ADDENDUM 002

project	LCSD Hillcrest Elementary	project no.	18285
date	8 February 2019	contractor	DWA Construction
owner	Logan City School District	bid date	12 February 2019

C6 MOBILE CABINET W/ MARKERBOARD

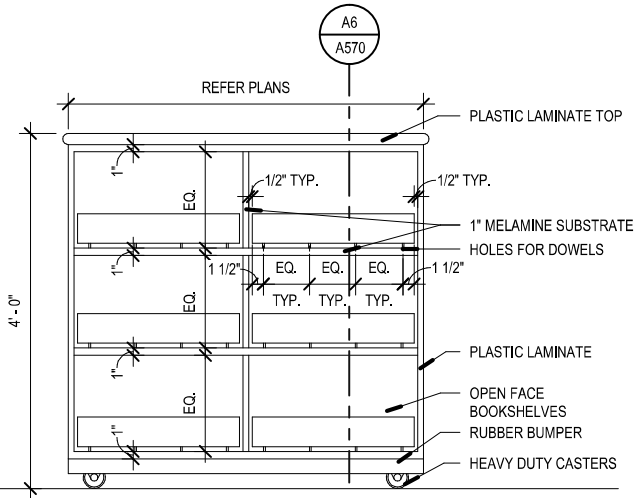
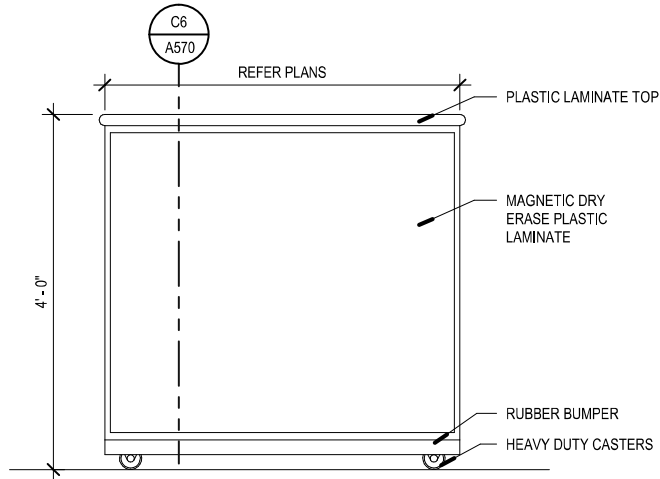
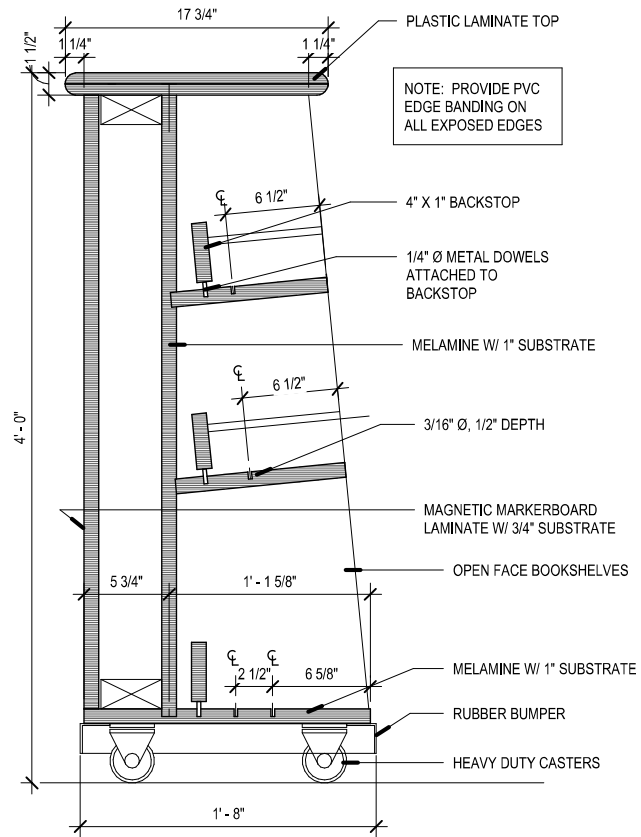
- Updated detail D1 to note clear sealed 1-1/2" maple top
 - Added detail for single sided book cart w/ whiteboard
 - Refer attached sketch
 - Updated detail C3 to provide plastic laminate bullnose in lieu of hardwood
